MONITORING YEAR 1 ANNUAL REPORT

HONEY MILL MITIGATION SITE

RE: Draft Year 1 Monitoring Report
Honey Mill Mitigation Site, Surry County
Yadkin River CU 03040101
DMS Project ID No. 100083 / DEQ Contract #007619

Wildlands Engineering, Inc. (Wildlands) has reviewed the Division of Mitigation Services (DMS) comments from the Draft Year 1 Monitoring Report for the Honey Mill Mitigation Site that were received on January 31, 2022. The report has been updated to reflect those comments. The Final MY1 Report is included. DMS' comments are listed below in **bold**. Wildlands' responses to DMS' comments are noted in *italics*.

Figure 1	Current Condition Plan View (Key)
Figures 1a-d	Current Condition Plan View

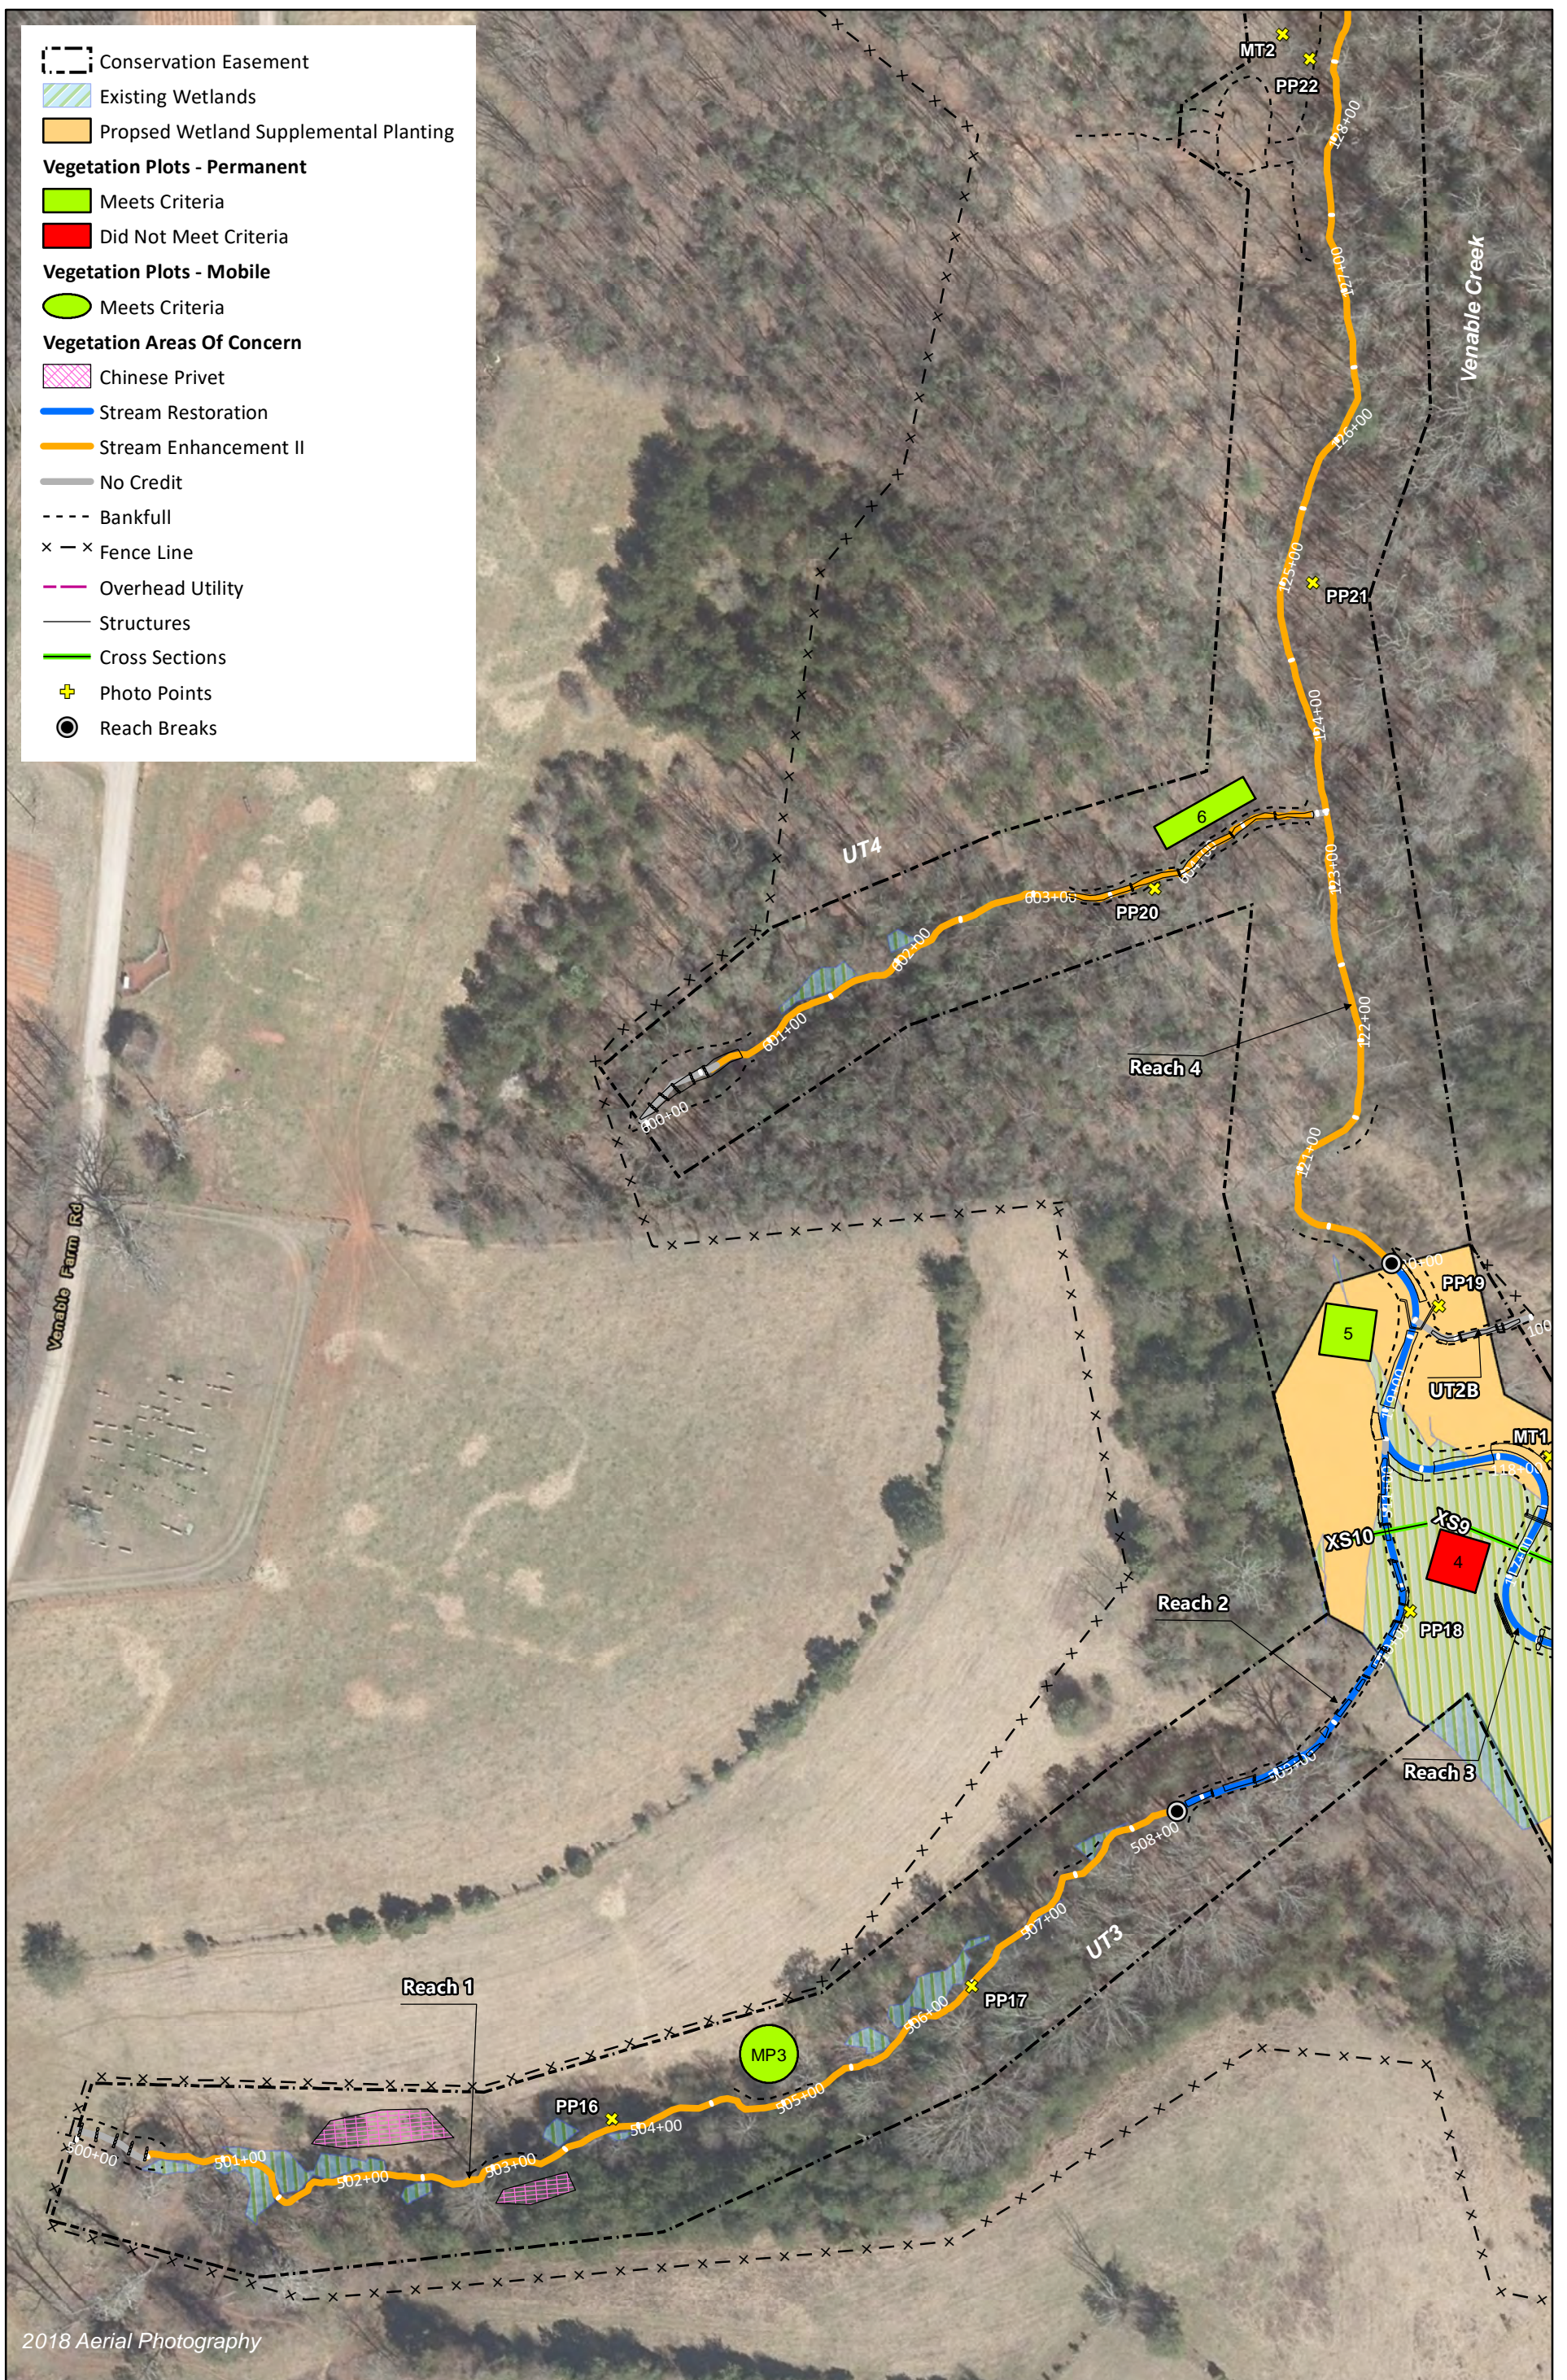
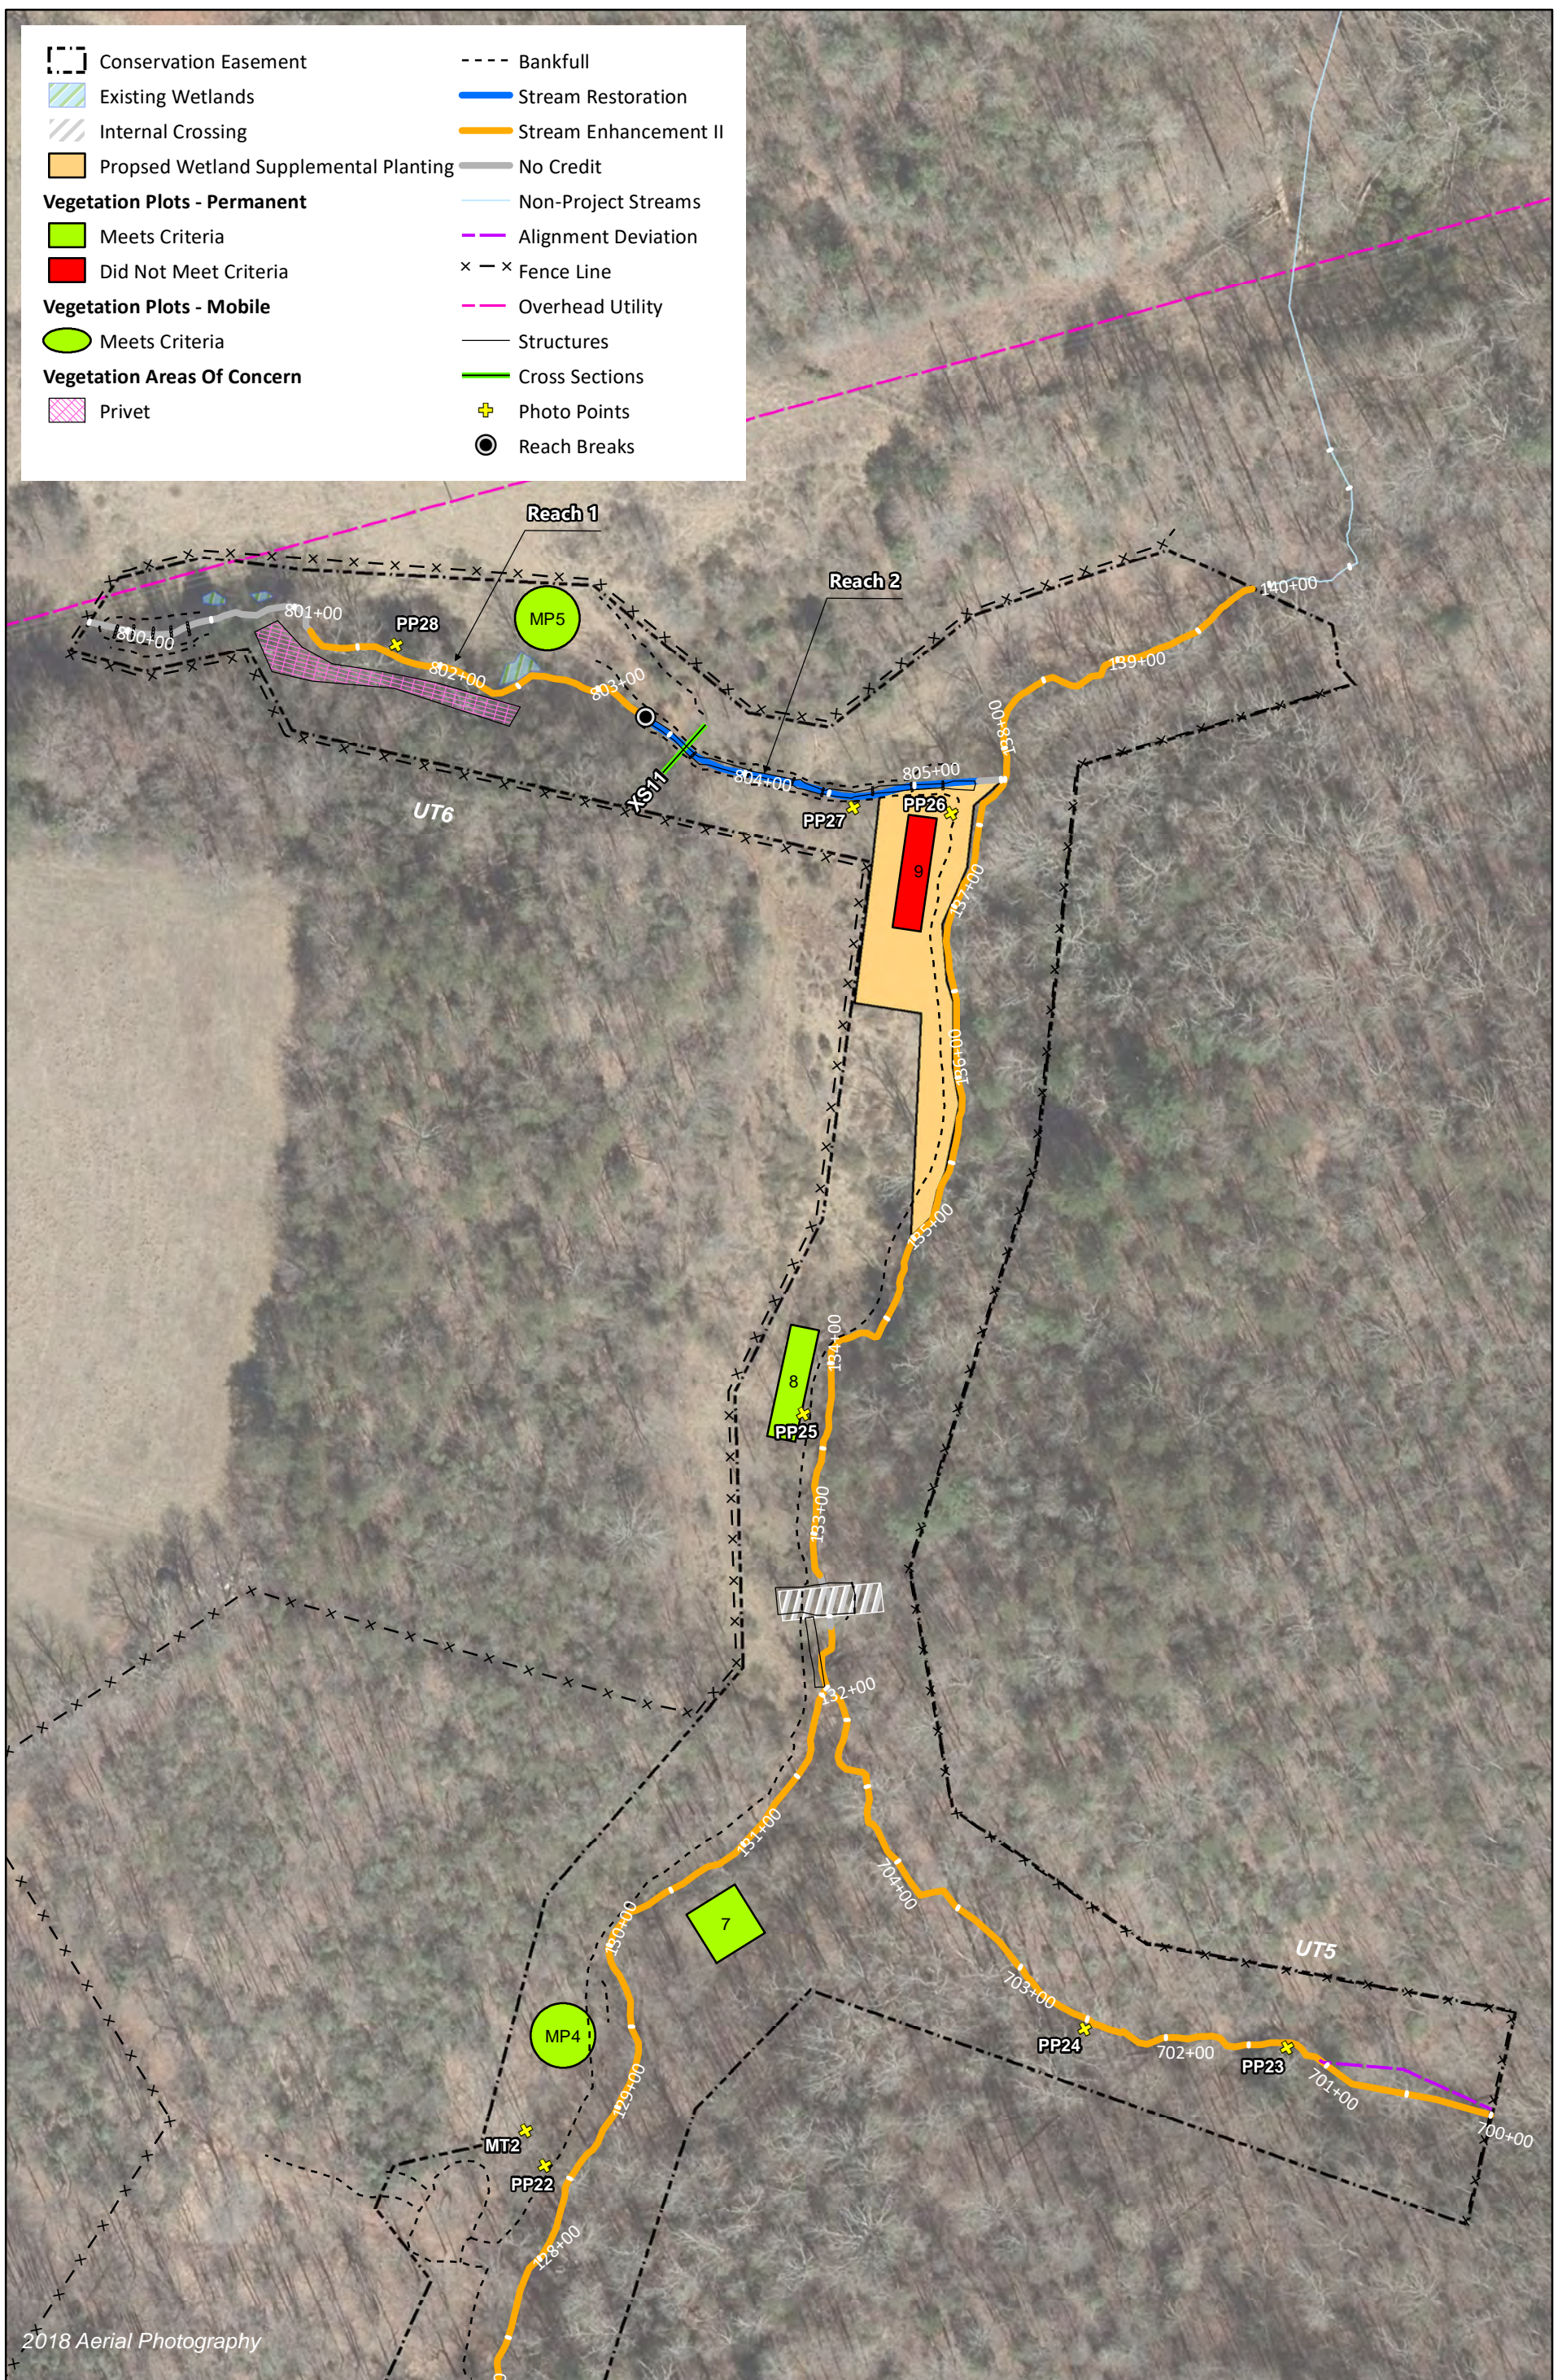
DMS' comment: Please include an outline showing the approximate 2.5-acre replanting areas on the CCPV Figures.

Wildlands' response: Figures have been updated to show the wetland supplemental planting area.
